LEVEL 2 REMODEL
SECTORS 5A, 5B & 6
COLLEGE COMPLEX
LOS MEDANOS COLLEGE
2700 EAST LELAND DRIVE
PITTSBURG, CA 94565

REQUEST FOR INFORMATION

RFI # 143

HVAC Ductwork in Restrooms 230 & 231

HVAC FLOOR PLAN - SECTOR 5A
SCALE: 1/8" = 1'-0"

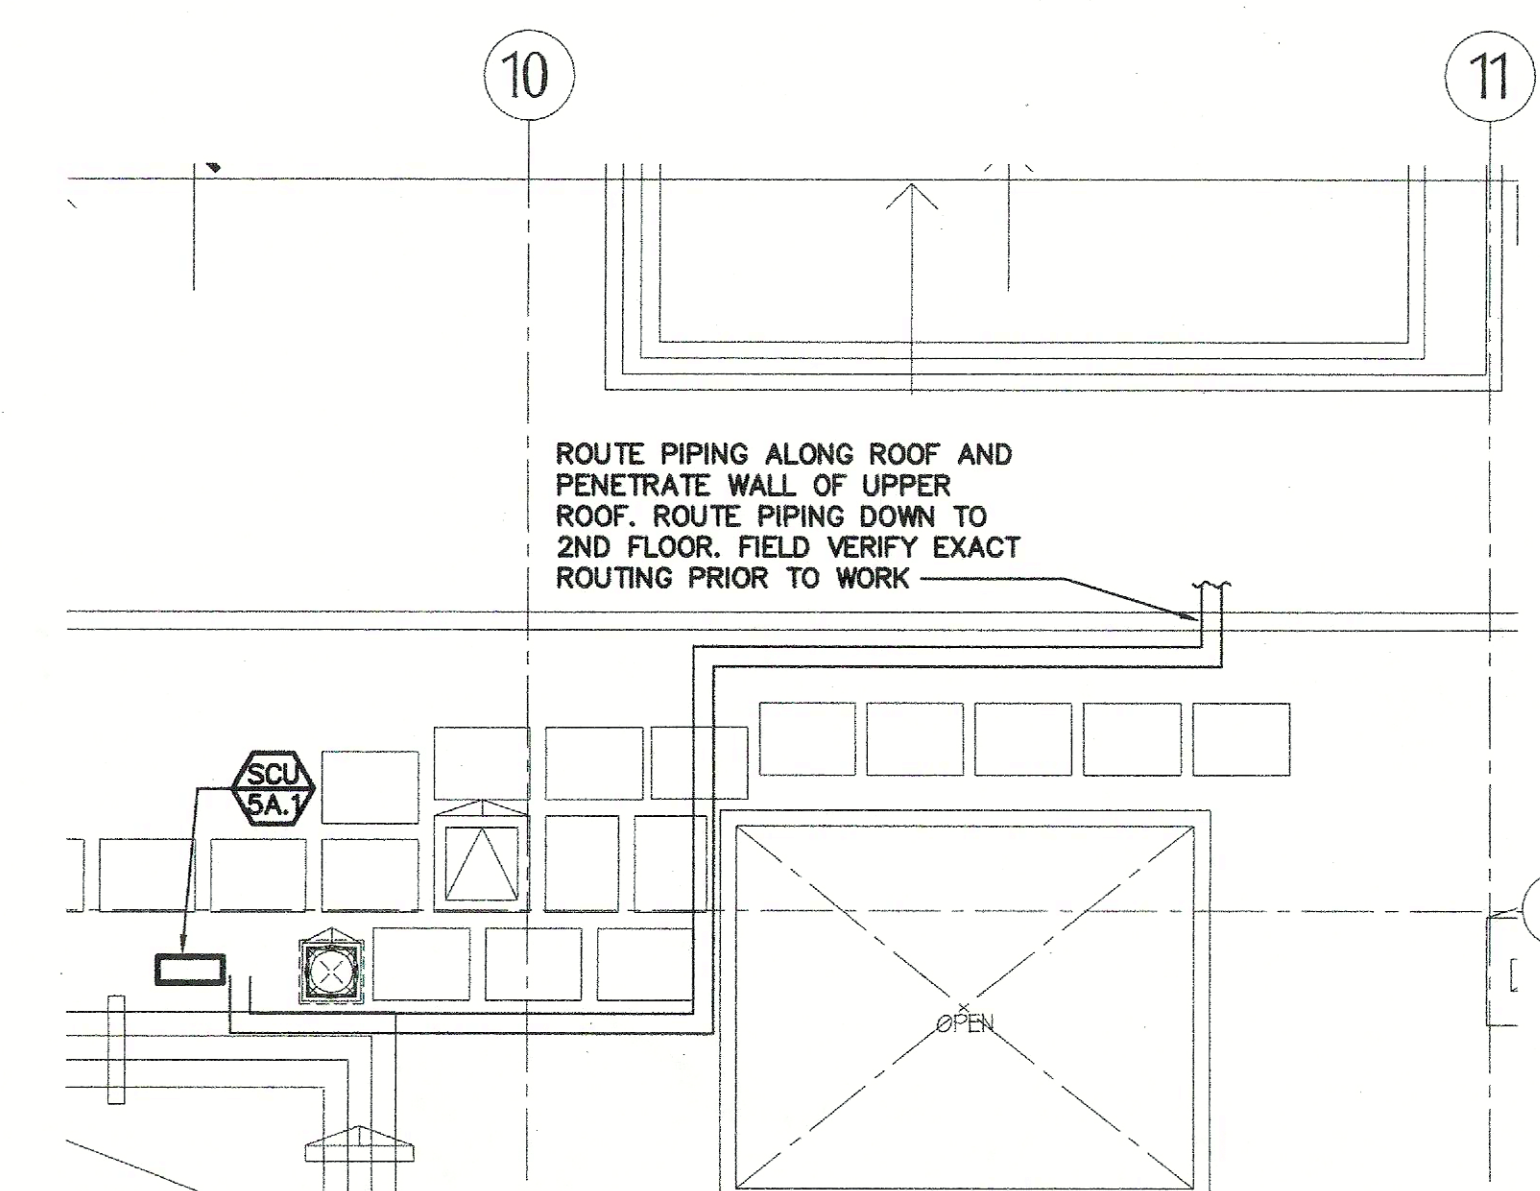
Duct work re-confirmed size/shape see ASI #5

RFA #1610 HVAC HW connection

References: Drawing MS.1
Published

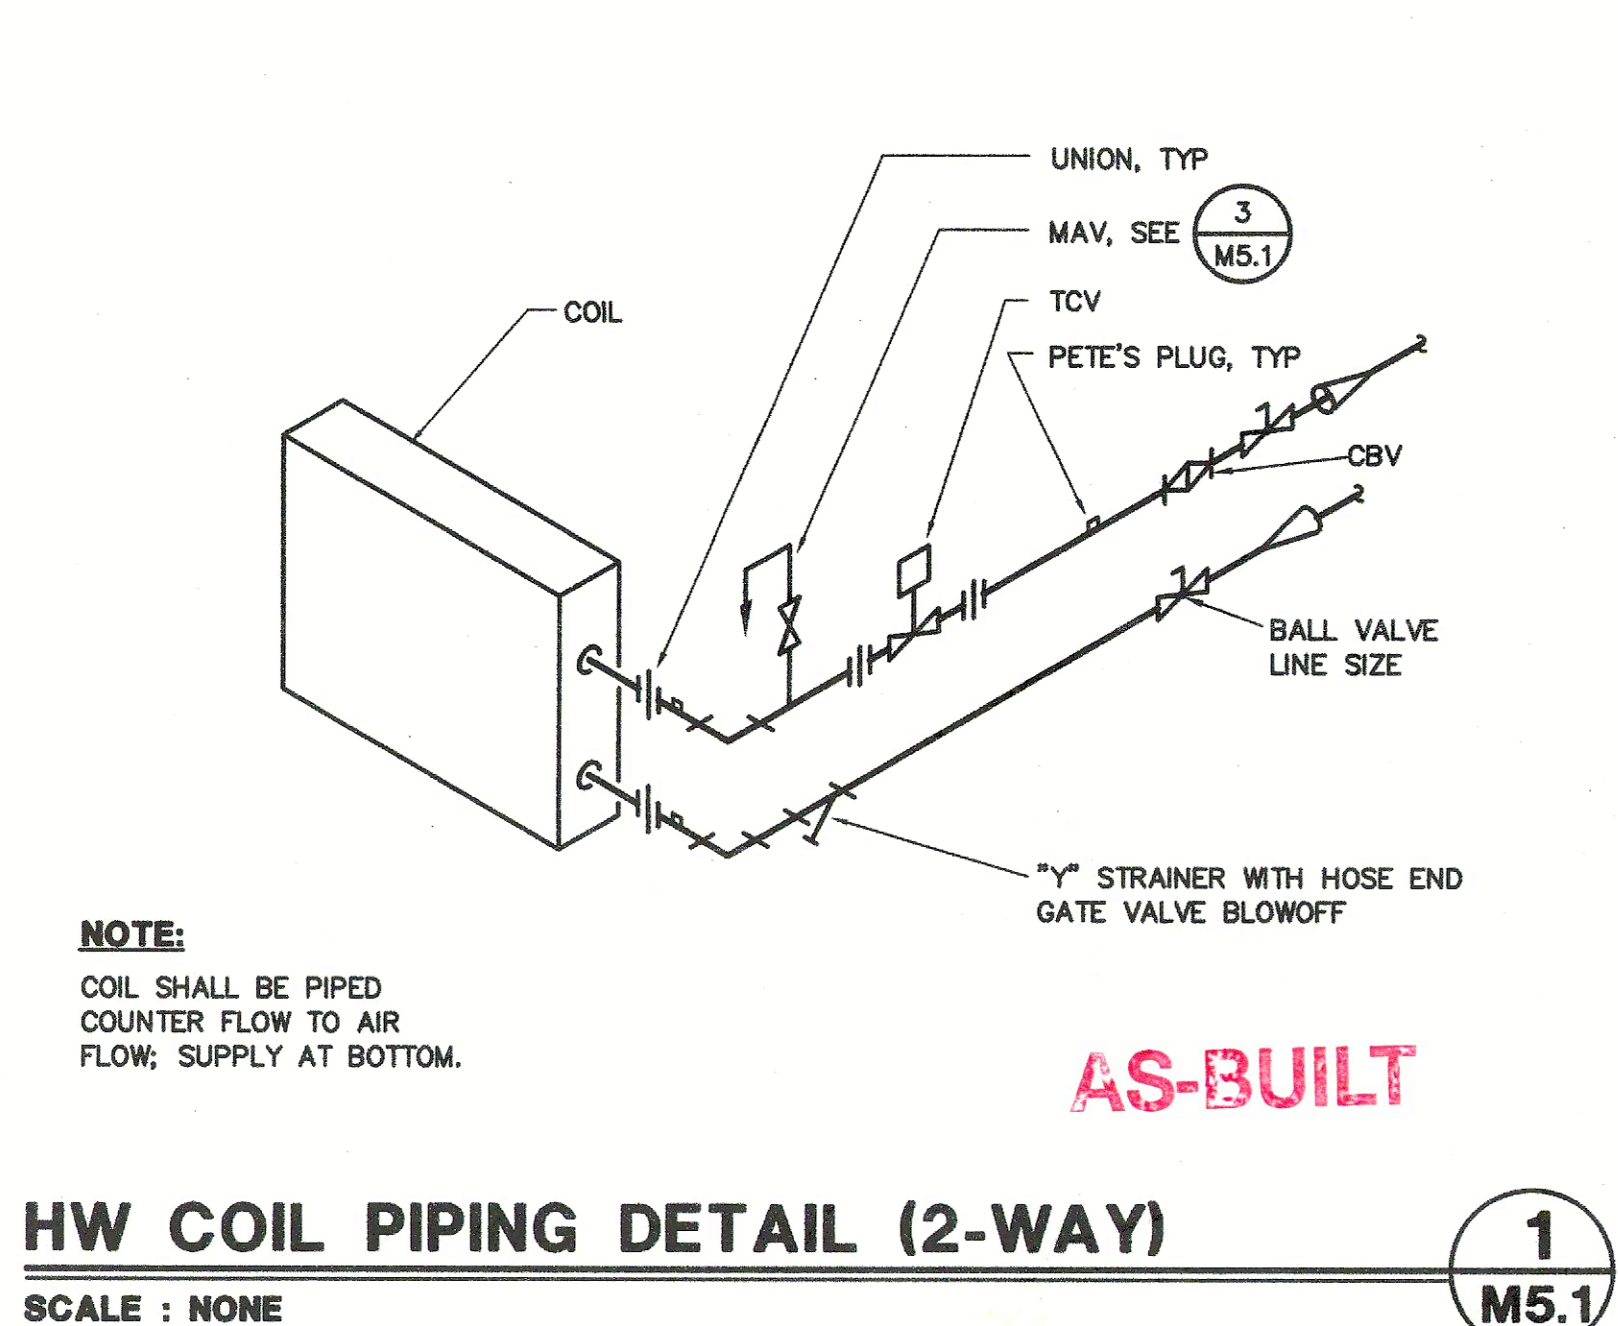
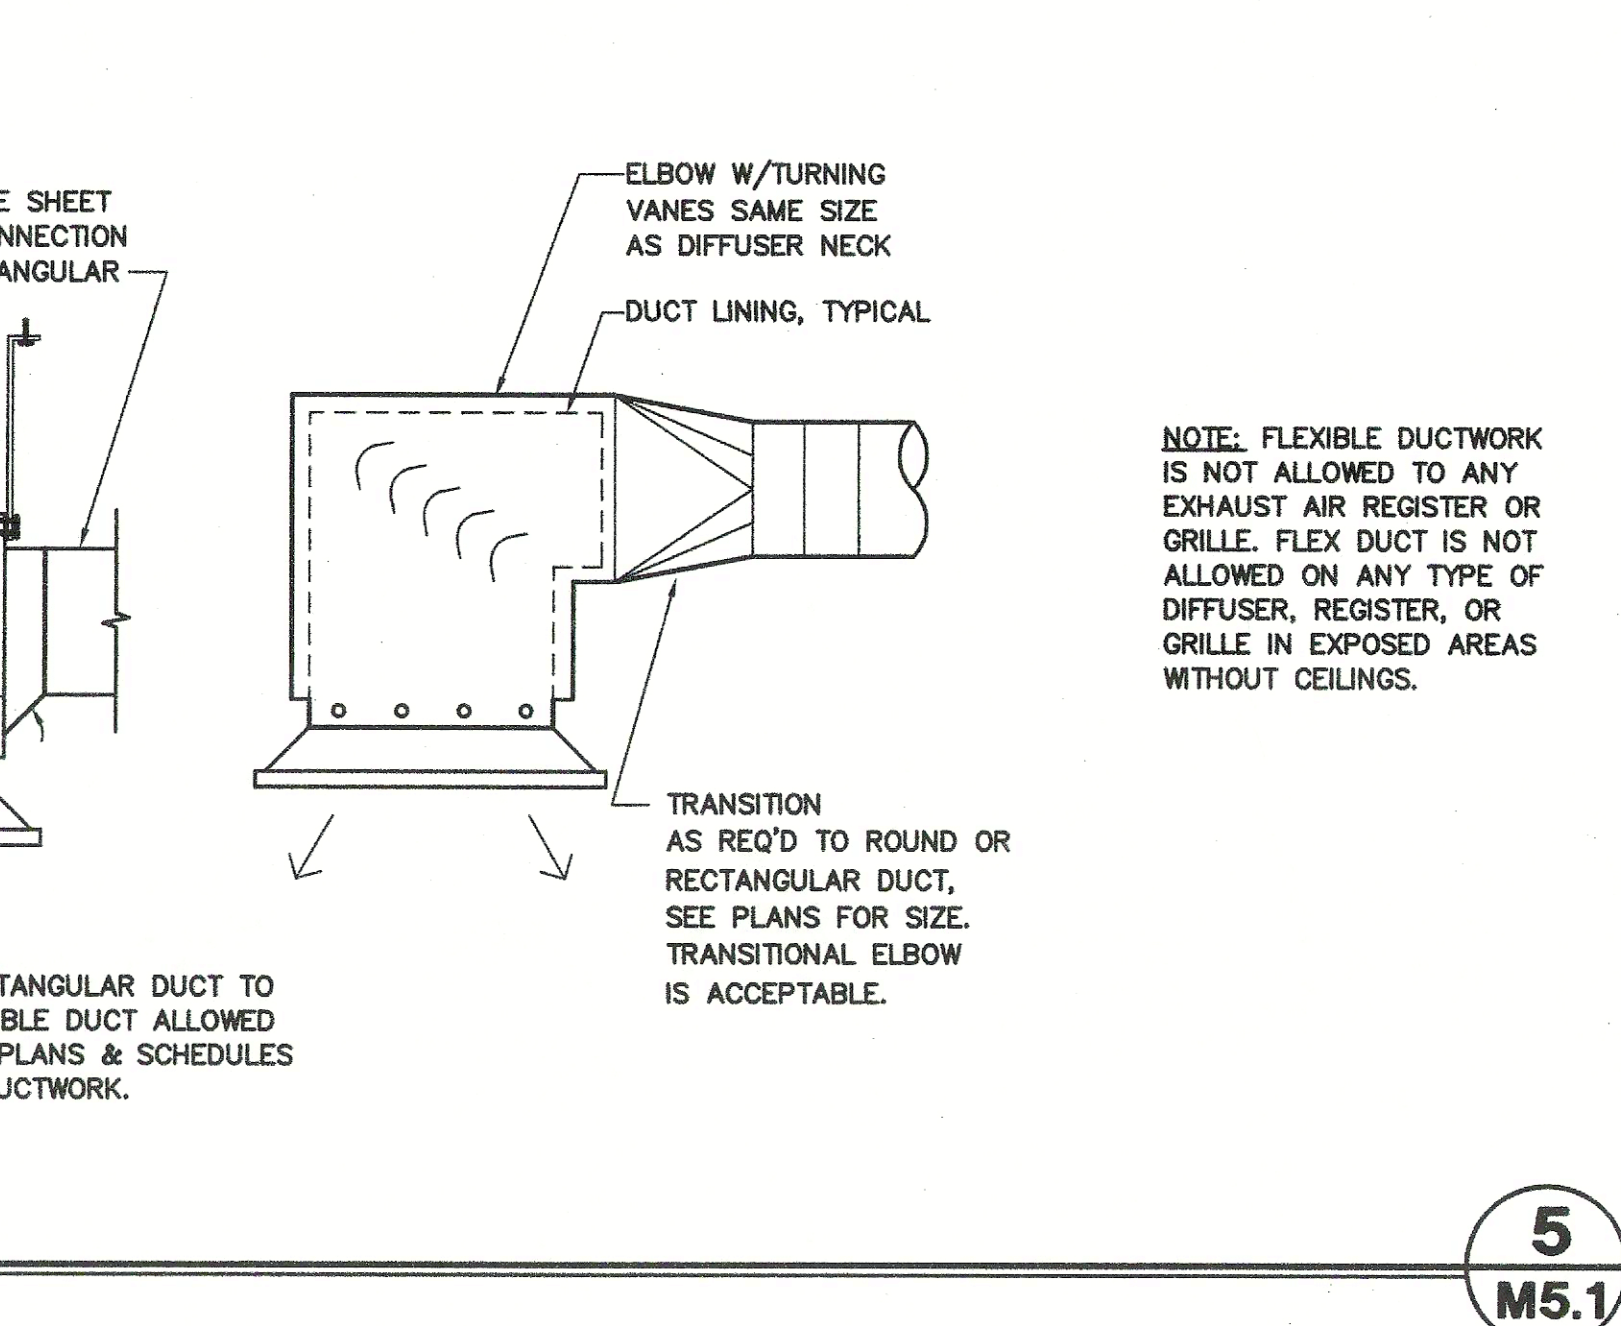
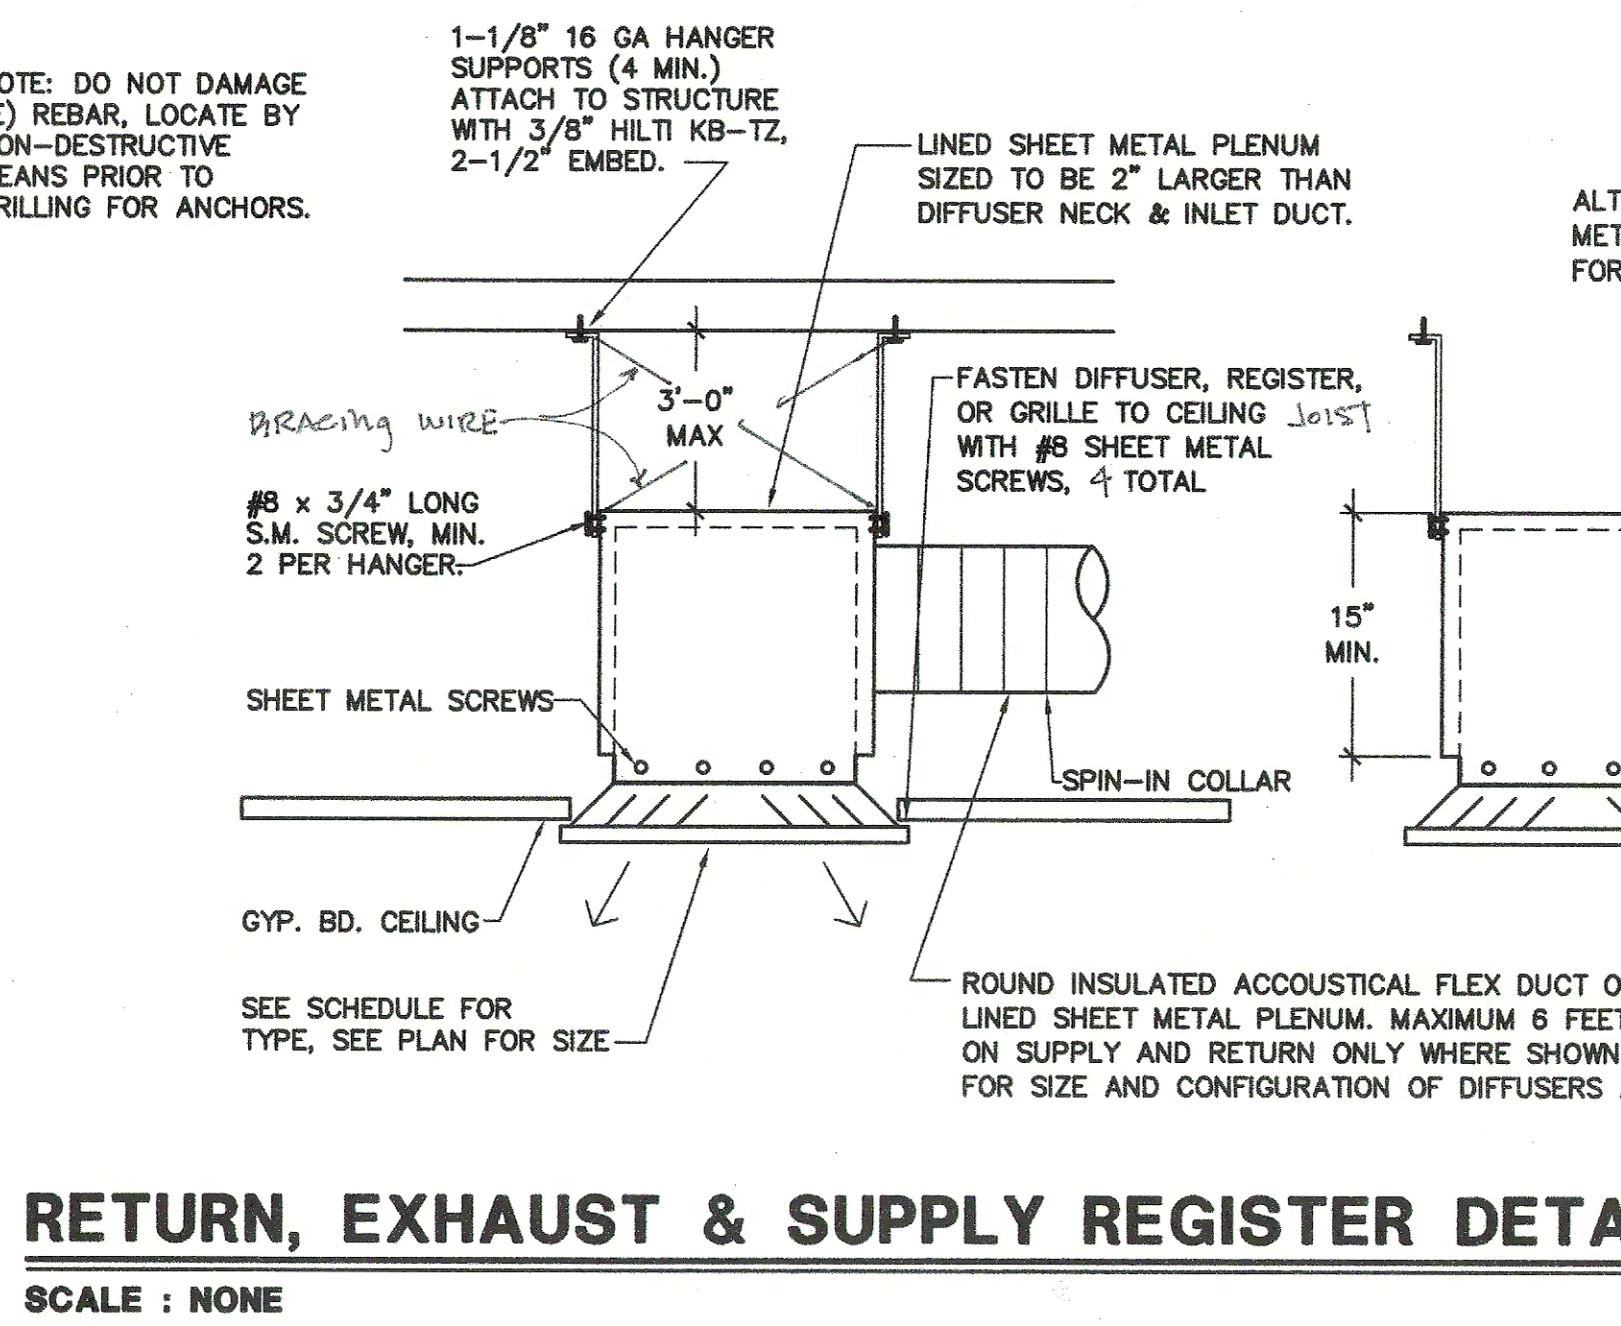
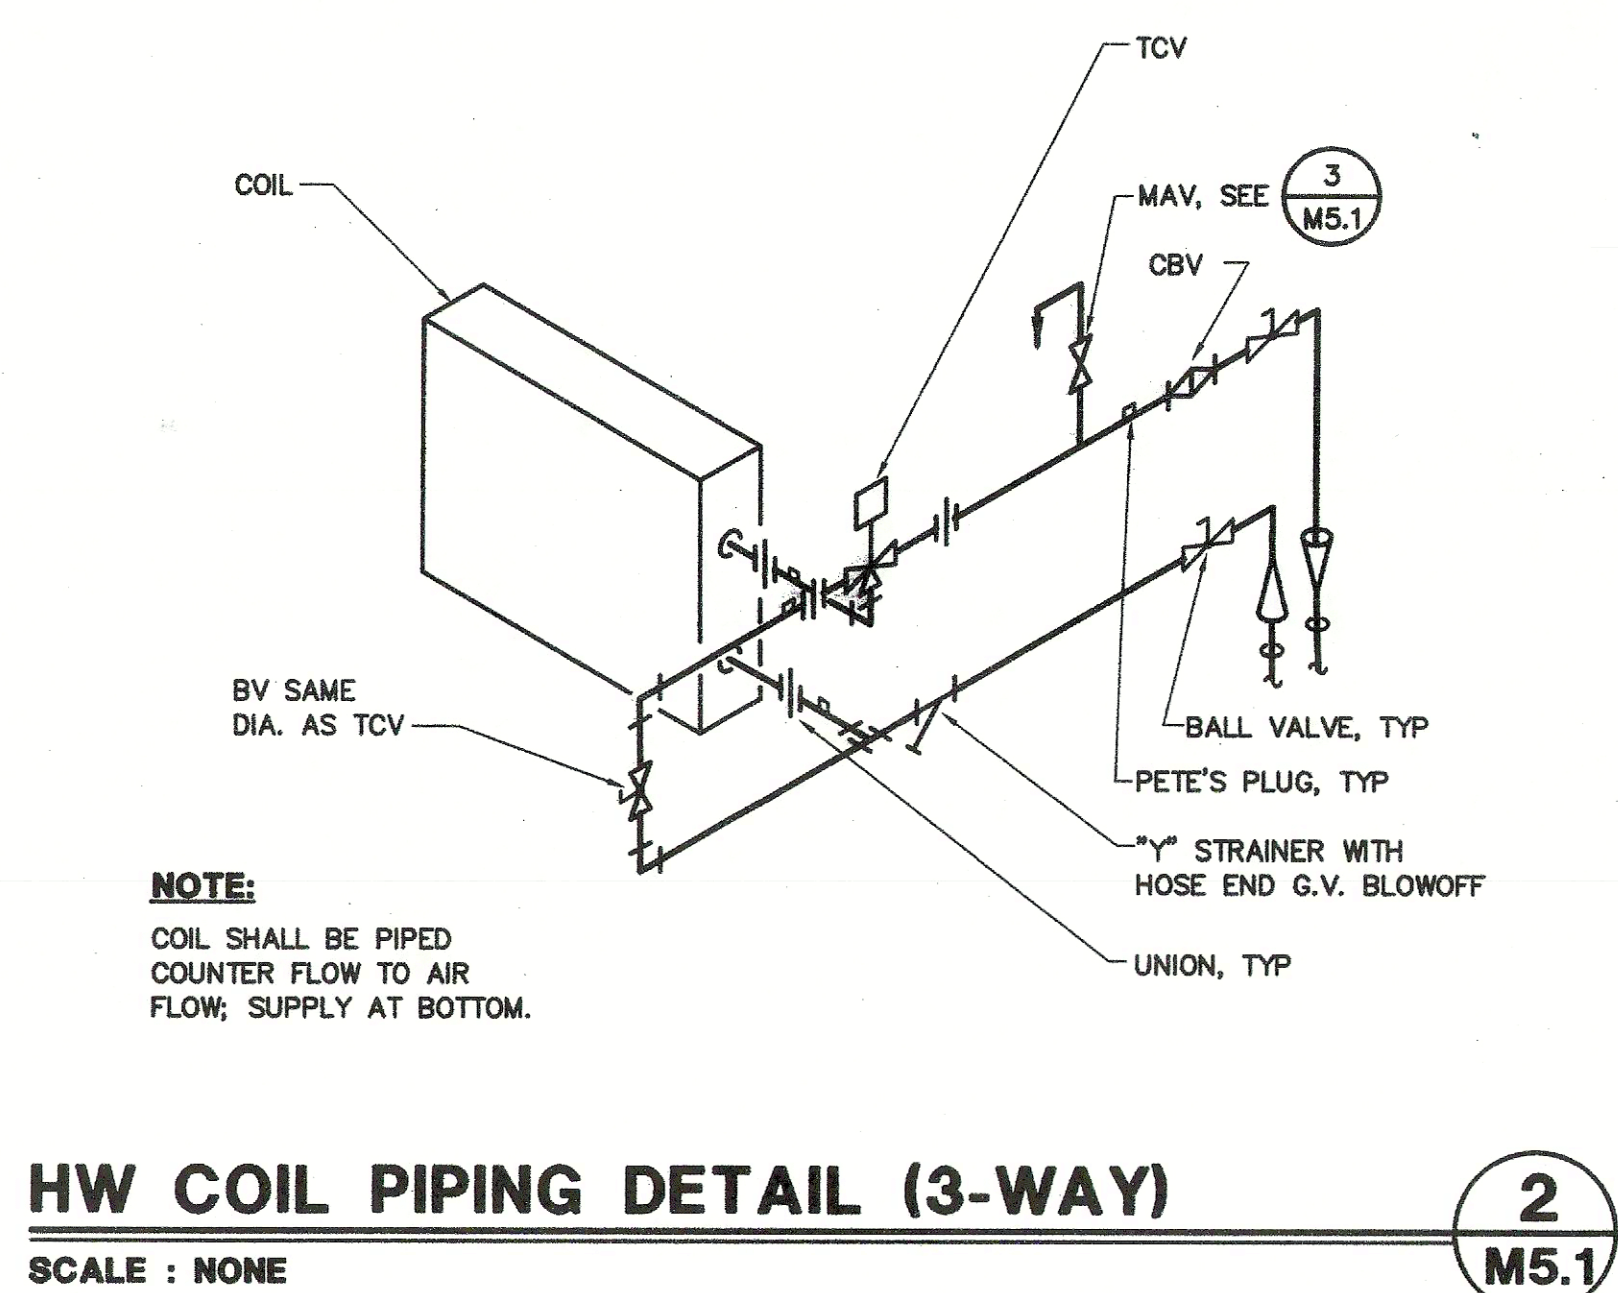
Request: Detail 8/A5.1 shows the Hill KB-1Z anchors installed inward from the vertical support. The existing support studs are centered on the concrete beam above with a stud/coupler connection (see attached photos). The existing support studs will need to be ground flush to make room. Question: what is the minimum distance needed between new and old anchors? Please advise. URGENT

Response: There are approximately 6 locations where the seismic brace detail for the HVAC VAV boxes will not work, they are too close to a wall. This typically occurs in the smaller offices in sectors 5A and 5B. Martinez Sheet Metal is proposing to attach the boxes to the adjacent wall with Unistrut, similar to the installation shown in the attached picture. This picture is in room 252.

Response: Bracing may be installed to wall or deck per 14/A7.3 (see attached marked up photo)
